## Camshaft Oil Seal Replacement - 45/50 (4-Stroke)

1995 and 1996 Model 45/50 (4-Stroke)

Serial Number USA 0G382347 and Below

**Figure 1. 45/50 Rework Identification Marking**

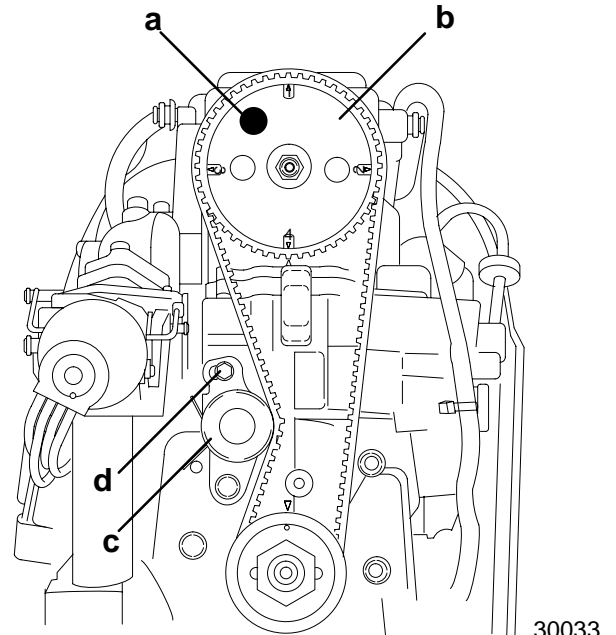
The listed 1995 and 1996 Mercury and Mariner outboards may have a loose fit between the upper camshaft oil seal and the seal bore in the cylinder head. Seals have pushed out of position creating a major oil leak which could cause a powerhead failure.

Outboards within the serial number range listed that have been reworked at the factory are identified by:

- A black paint dot on the camshaft driven gear (Figure 1).

8. Reinstall camshaft driven gear and timing belt as outlined in outboard service manual.
9. Apply a black paint dot on the camshaft driven gear as shown in (Figure 1) to indicate a repaired seal.
10. Allow Loctite to cure overnight before placing unit into service.
